TB 11-6625-821-35

CHANGE 1

CALIBRATION PROCEDURE FOR DIRECTION FINDER SET TEST SET AN/ARM-93 (NSN 6625-00-999-6081)

TB 11-6625-821-35, 9 August 1973 is changed as follows:

Figure 1. Fabricated cable for the BEARING INDICATOR, construction details.

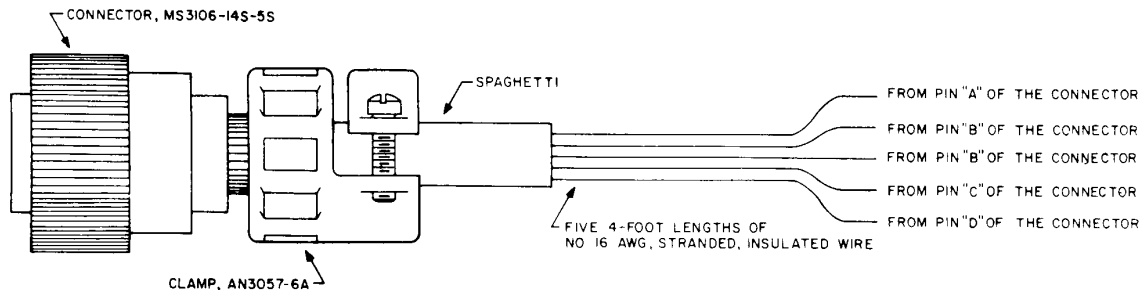
Paragraph 6, table 1B. "None required" is superseded as follows:

Banana plug to banana plug lead	2 required
Banana plug to pin adapter	2 required
Banana plug to alligator clip	Quantity as required
Fabricated cable (fig. 1)	Some modification of this cable is permissible as to size, length, and loose ends.

Figure 8. Test equipment connections for LOOP SIMULATOR Zero Calibration.

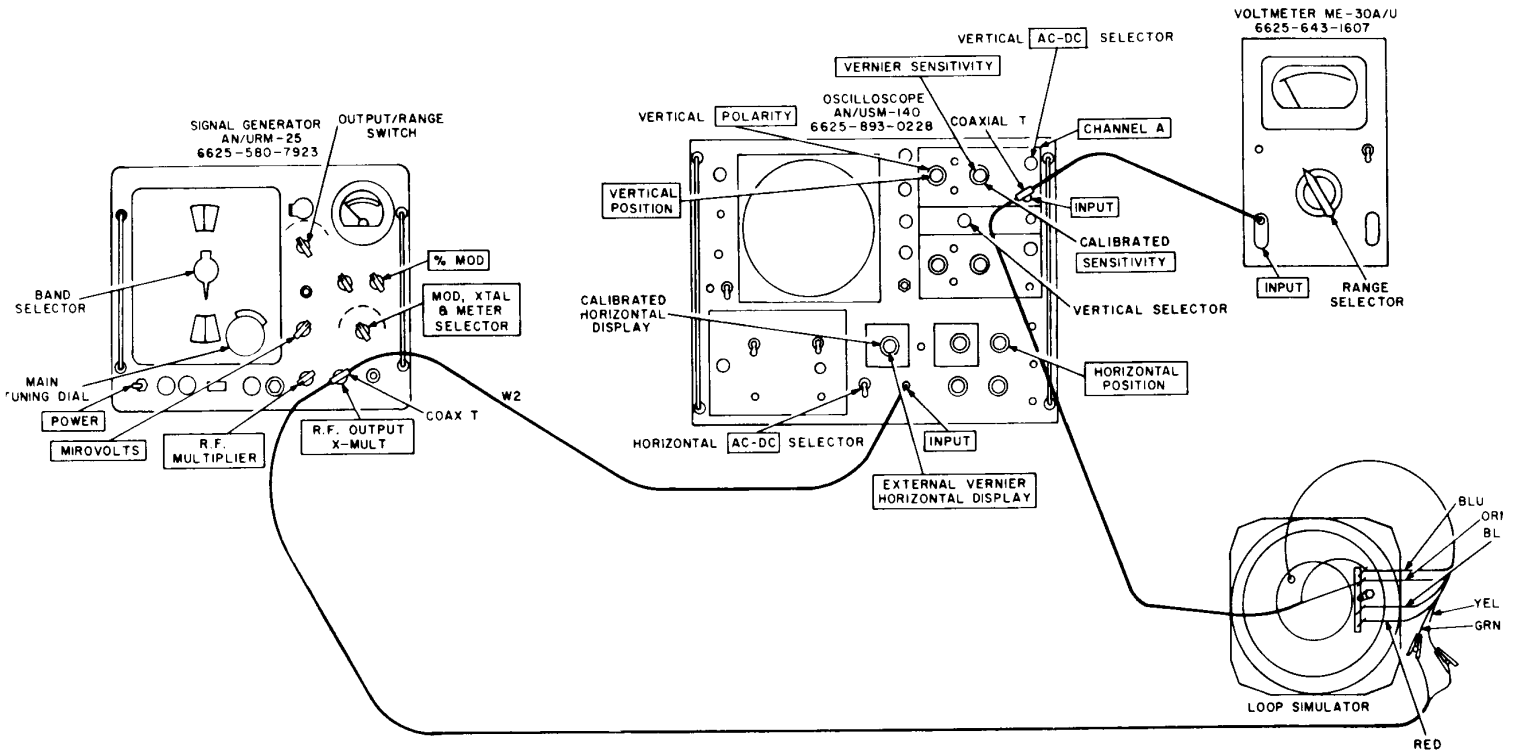
Paragraph 9a(2), lines 5 through 7. Lines 5 through 7 are changed to read: “the negative lead to the yellow wire on B1. Connect the hot lead from the oscilloscope to the blue wire on resolver B1 and the negative lead to the orange wire.”

Figure 9. Test equipment connections for BEARING INDICATOR Zero Calibration.

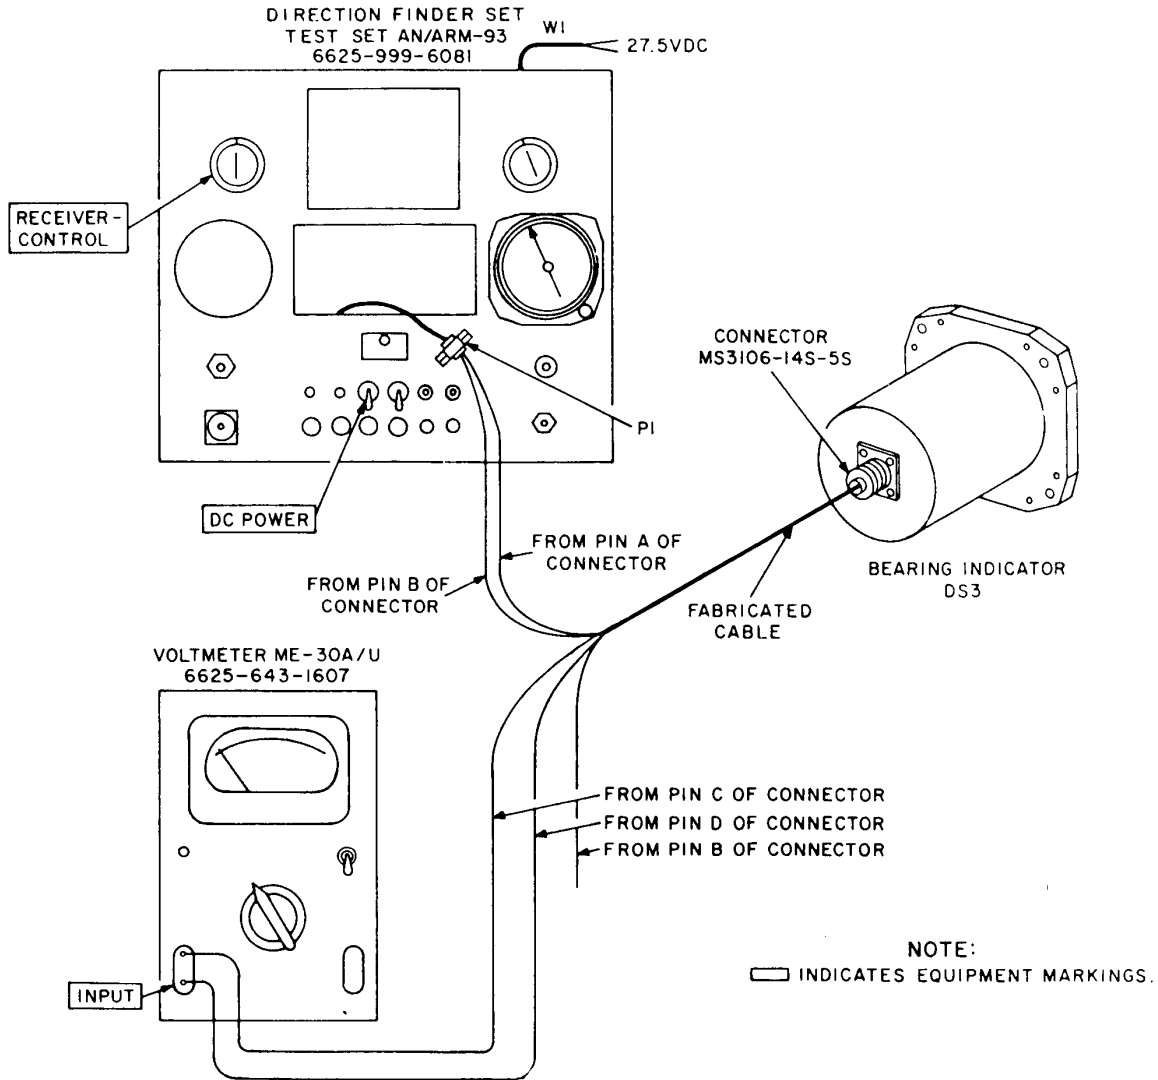
Paragraph 10a(2), lines 3 and 4. “and detach cable from each unit” is superseded as follows: “remove cable from bearing indicator and leave cable to direction finder control intact. Set DF control to ADF.”

Paragraph 10a(6), line 3. “pin M” is changed to read: “pin A.”

Paragraph 10a(7), line 3. “pin H” is changed to read “pin B.”
